NPP FENNOVOIMA (HANHIKIVI 1)

Expert Statement to the Environmental Impact Assessment Report

REPORT
REP-0479

Figure 1: Interpolated annual sea level averages and the average water level scenario with uncertainties in Pyhäjoki until 2100.

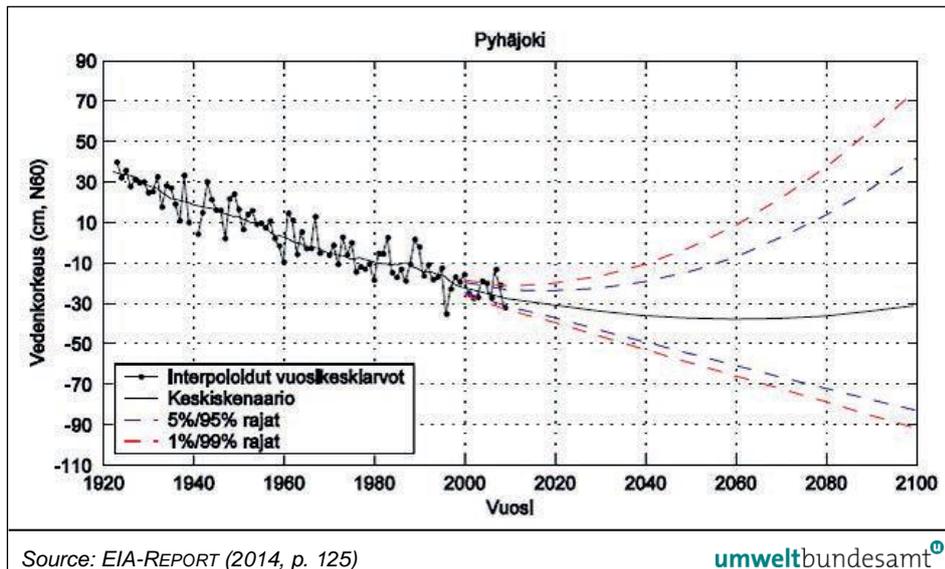
Figure 7-10 of the EIA-REPORT (2014, p. 125) illustrates the interpolated annual sea level average with uncertainties until the year 2100 (see Figure 1). Figure 1 shows that in 2100, compared to the average value, the sea level average could be 50 cm lower or 70 cm higher (95% fractile)⁶.

According to the EIA-REPORT (2014, p. 56), in 2075 the sea level will fluctuate between -179 cm and +201 cm. In 2008, the sea water level fluctuation was between -152 cm and 228 cm.
